# Service Bulletin

Bulletin No.: 17-NA-305

**Subject: Malfunction Indicator Lamp (MIL) Illuminated – DTCs P0615, P0617, P305C, P305D, P305E and/or P3054 Set**

4225184

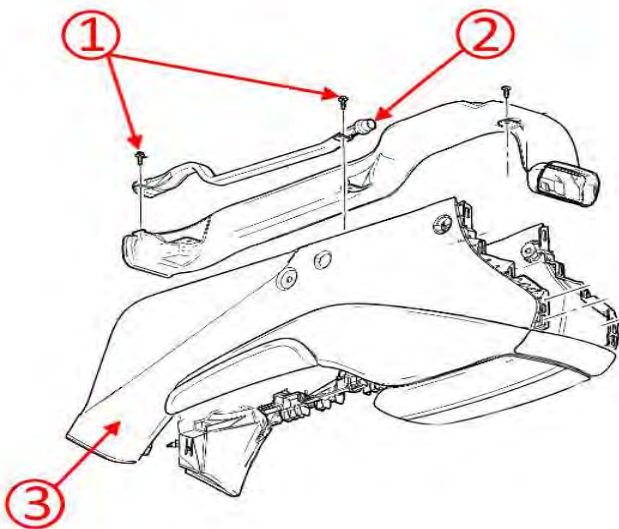
1. Remove the front floor console (5). Refer to *Front Floor Console Replacement* in SI.
